Access Compliance Report

(Curb Ramps)

Intersection ID: 28521	Main Street: LIONSTONE_DR	Cross Street: GARRISON_RD	Location:	N
ADA ID: 050080BC33CE	Ramp Type: Perp	Initial Pass/Fail: Fail	Overall Compliance: No	Severity Score: 21.25
Codes/Mitigation Info/Possible Solution		Field Measurements/Component Compliance

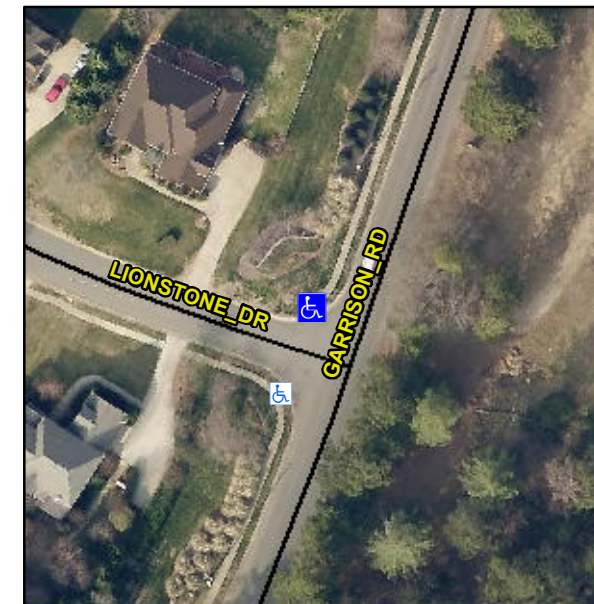
Not Found, R304.5.1, R304.5.3

Compliance	Description	Data	Compliance	Description	Data
N/A	Ramp Length (in)	44.0	Yes	Ramp Slope (%)	5.4
No	Ramp Width (in)	44.0	No	Ramp XSlope (%)	5.9
N/A	Flare Type LT	N/A	N/A	Flare Type RT	N/A
N/A	Flare Slope LT (%)	N/A	N/A	Flare Slope RT (%)	N/A
N/A	Flare Traversable LT?	N/A	N/A	Flare Traversable RT?	N/A
N/A	Landing Length (in)	N/A	N/A	DWS Provided?	N/A
N/A	Landing Width (in)	N/A	N/A	DWS Contrast?	N/A
N/A	Landing Slope (%)	N/A	N/A	DWS Length (in)	N/A
N/A	Landing X Slope (%)	N/A	N/A	DWS Full Width?	N/A
N/A	Landing Curb? (Y/N)	N/A	N/A	DWS Offset (in)	N/A
N/A	Shared Landing?	N/A			
N/A	Gutter Ponding?	N/A	N/A	Gutter Slope (%)	N/A
N/A	Gutter Lip Ht (in)	N/A	N/A	Gutter X Slope (%)	N/A
N/A	Painted X Walk1?	No	N/A	Painted X Walk2?	N/A
	X Walk 1 Direction	To SW		X Walk 2 Direction	N/A
N/A	X Walk 1 Width (in)	N/A	N/A	X Walk 2 Width (in)	N/A
	X Walk 1 Slope (%)	0.7		X Walk 2 Slope (%)	N/A
	X Walk 1 X Slope (%)	2.9		X Walk 2 X Slope (%)	N/A

Remove & Replace Entire Ramp.
